ADDENDUM NO. 1

This addendum modifies the Contract Documents dated December, 2022, for the San Lorenzo Valley Water District Redwood Park Pipeline Project, and the work shall be accomplished in accordance with such modifications. This Addendum includes two (2) pages plus three (3) attachments (total of 13 pages).

REDWOOD PARK PIPELINE

SD-3 STANDARD 6" STEAMER FIRE HYDRANT

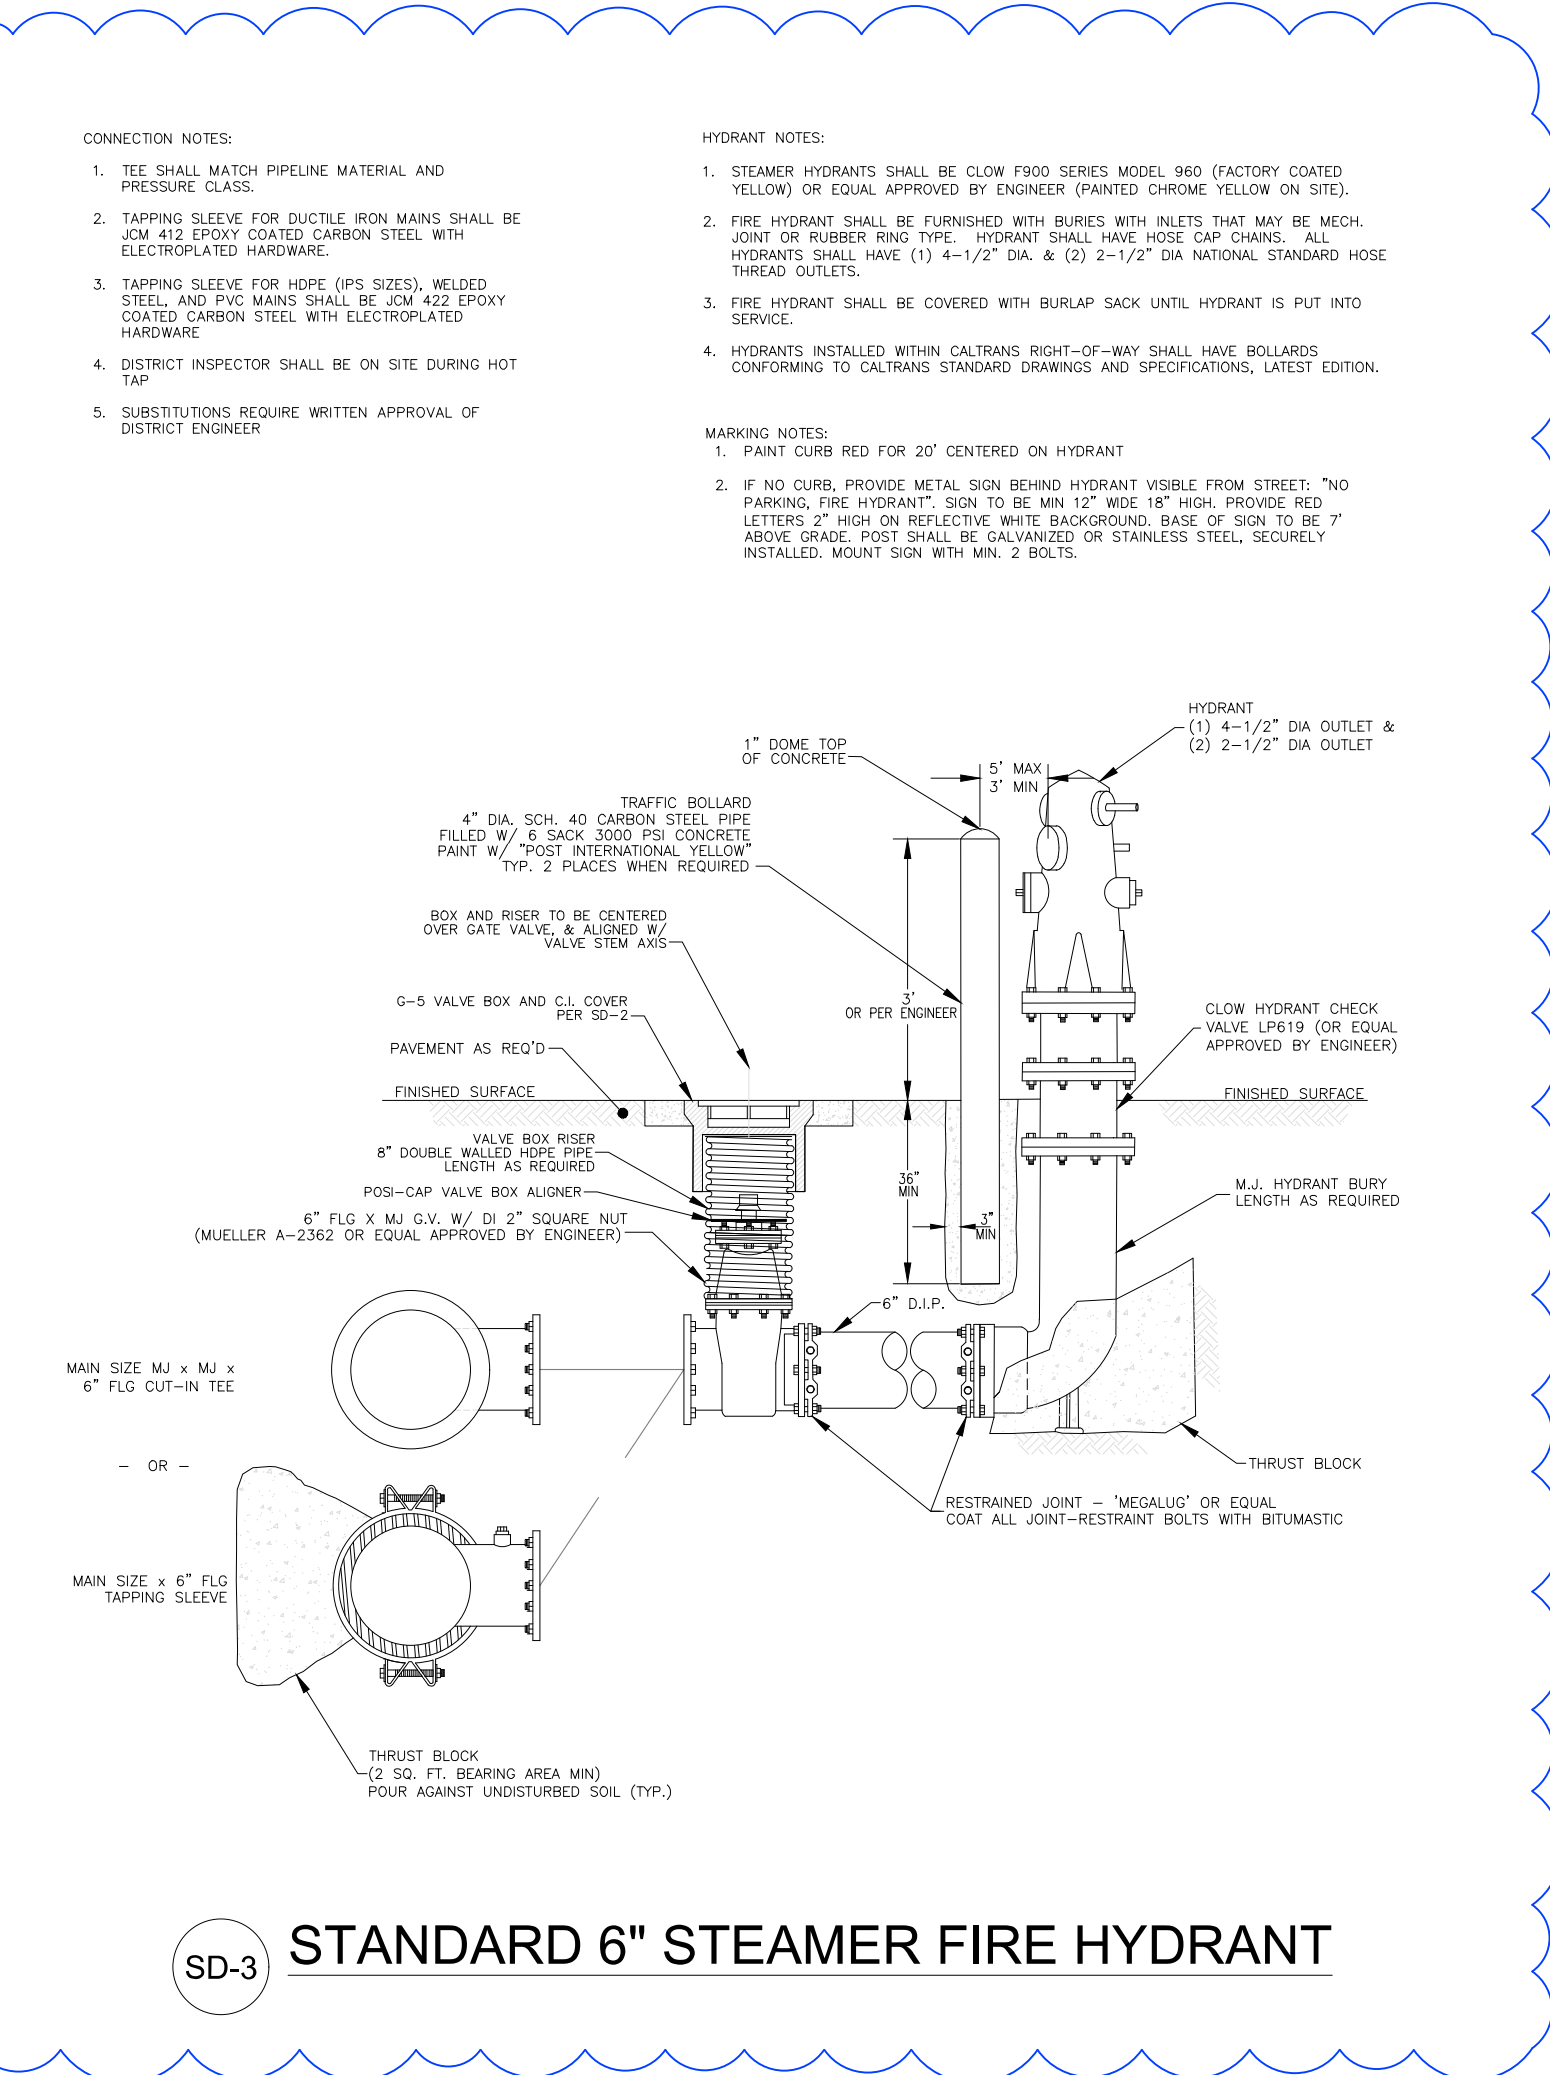
“23. Minimum wall-to-wall separation between pipes is to be 12-inches, unless otherwise specified.”
- B. Sheet C3.0, Proposed Site Plan is revised. The changed sheet is attached.
- C. Sheet C3.1, Proposed Details is revised. The changed sheet is attached.
- D. Sheet C4.0 Utility Details is revised. The changed sheet is attached.
